RE: Further Response to EPA Review of Submissions for HVO South Modification 5

The following outlines additional information and clarification to address the further request for information from New South Wales (NSW) Environment Protection Authority (EPA) relating to the Response to Submissions prepared for the Air Quality and Greenhouse Gas Assessment (AQA) for the Hunter Valley Operations South (HVO South) Modification 5 (**Todoroski Air Sciences, 2017**).

Figure 1: Times series plots comparing predicted 24-hour average PM10 impacts at Assessment Location 126 without (above) and with (below) reactive measures during Stage 2

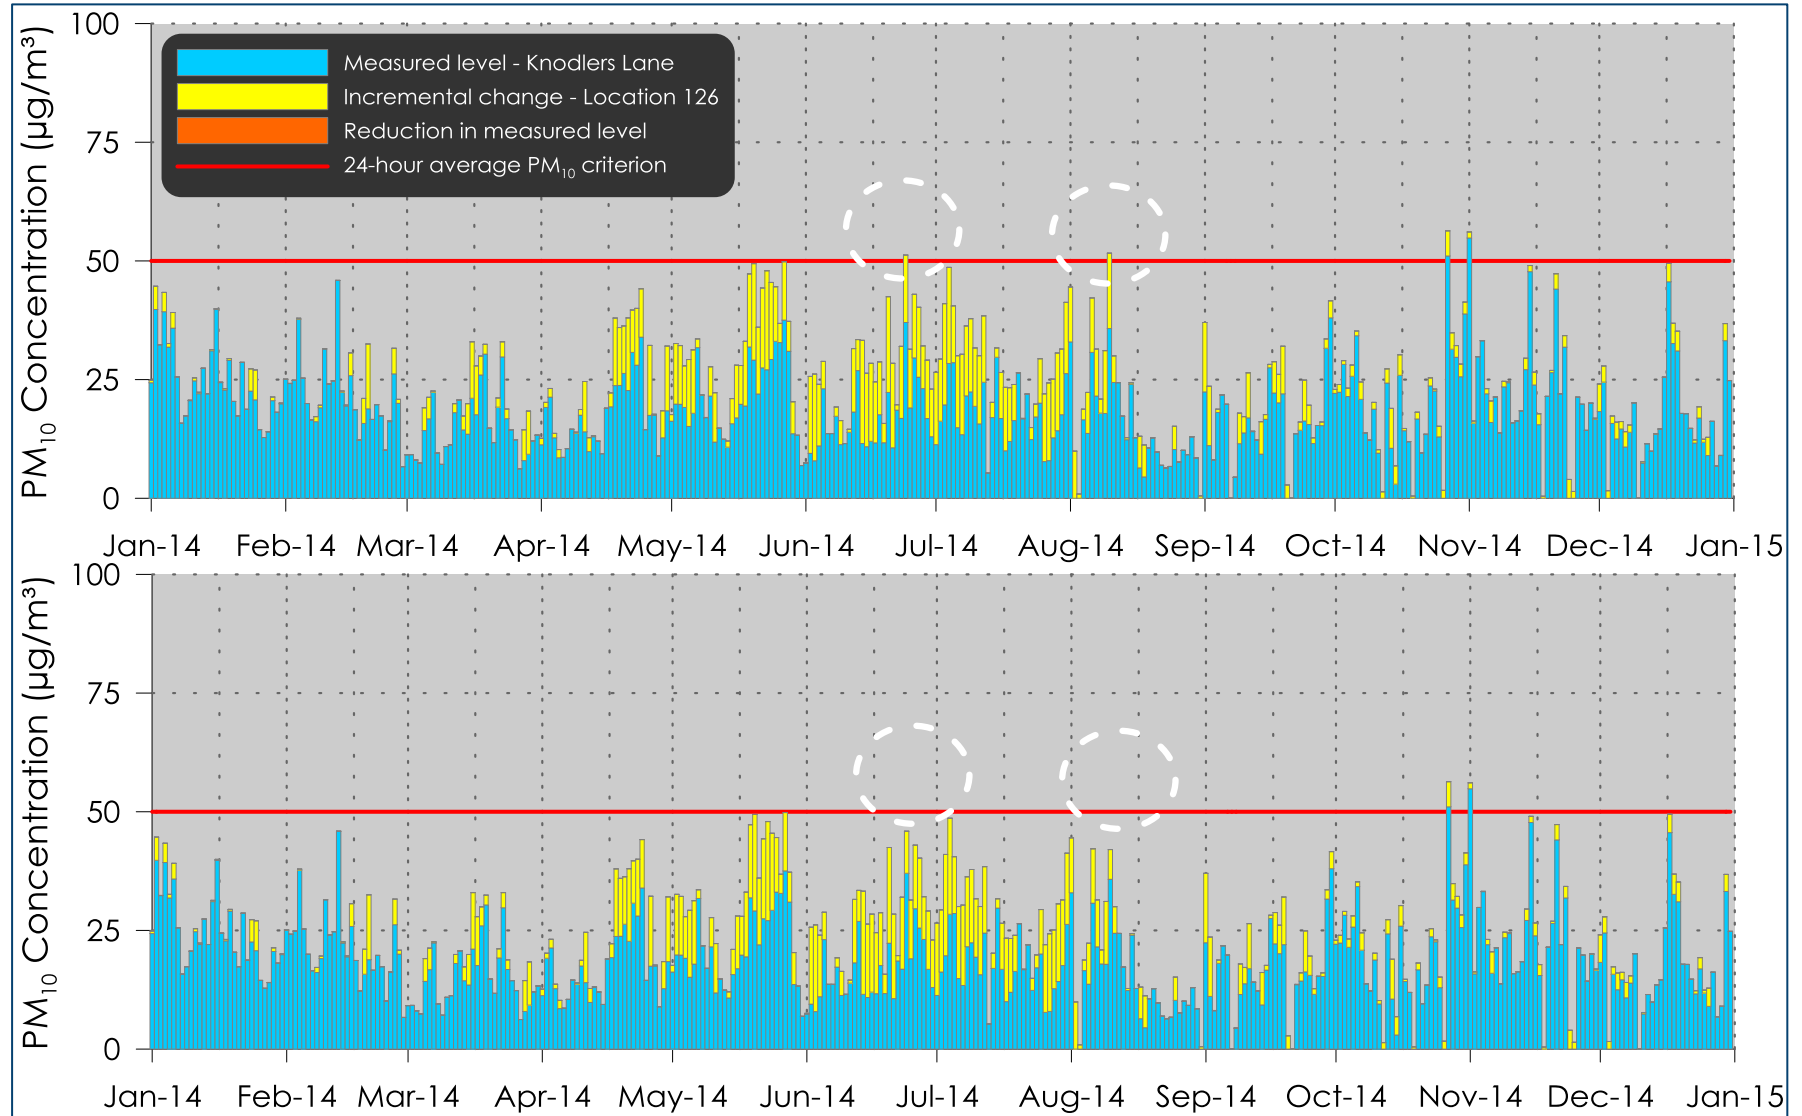
The RTS has stated the intended approach to mitigating the assessed additional exceedences of 24-hour impact assessment criteria. There is no analysis indicating the effectiveness of the planning and reactive management systems. In particular, there is no direct estimate of the ability of the system to mitigate the assessed additional exceedence days.

Section 7.7 of the Approved Methods Modelling requires that where impact assessment criteria are exceeded, additional mitigation measures must be assessed until compliance is achieved. To meet this requirement, evidence needs to be provided that the proposed management actions remove the additional exceedences of impact assessment criteria.

- The EPA requires assessment showing that the proposed reactive management successfully identifies the additional exceedences and reduces emissions sufficiently that the exceedences do not occur.*

To evaluate the effectiveness of the implementation of such reactive or predictive management systems at HVO South, the dispersion modelling was re-run to consider the effects of applying reactive control measures that would temporarily pause activities in the pit and overburden areas during periods of elevated dust.

Only the activities that can be controlled in the pit and overburden areas were ceased in the model, and dust from all other sources such as wind erosion remained as a source of dust in the modelling, representing the implementation of mitigation measures.

The effectiveness of this measure is demonstrated in the times series plots in **Figure 1** and **Figure 2** for assessment locations 126 and 309 during Stage 2 and in **Figure 3** to **Figure 5** for assessment locations 126, 160 and 309 during Stage 3.

The results in these figures indicate that with the implementation of mitigation measures, the predicted exceedances of the 24-hour average PM₁₀ air quality criteria could be averted at these locations. The indications are that use of reactive/ predictive controls would not lead to any additional day above the criteria in this case, demonstrating that the proposed system does have the ability to mitigate these potential exceedances.
